Rezoning Transportation Analysis

Petition Number: #2022-109

General Location Identifier: 09709418

Date	Description
11-28-22	First Review (IW)
12-21-22	Second Review (IW)

Reference (CLDSM standard detail U-02) for residential medium street typical.

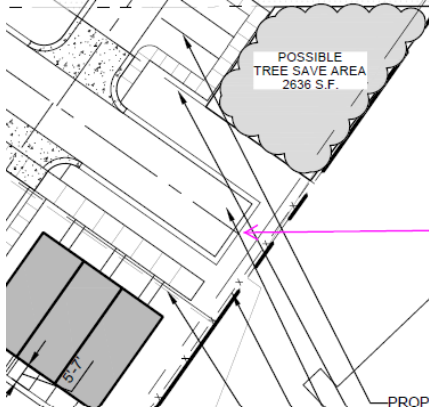
4. The proposed dwelling units exceeds 12 per acre. Per Chapter 20 Subdivision ordinance, site plan and conditional note(s) revisions are needed to commit to construct an 8-foot planting strip, and 8-foot sidewalk along all public roads. The wider sidewalk also meets the Charlotte WALKS Policy.

Clarifying Comment 12-21-22: Petitioner should add conditional note stating commitment of 8' planting strip and 8' sidewalk along both sides of all public roads. Reference (CLDSM standard detail U-02) for residential medium street typical section.
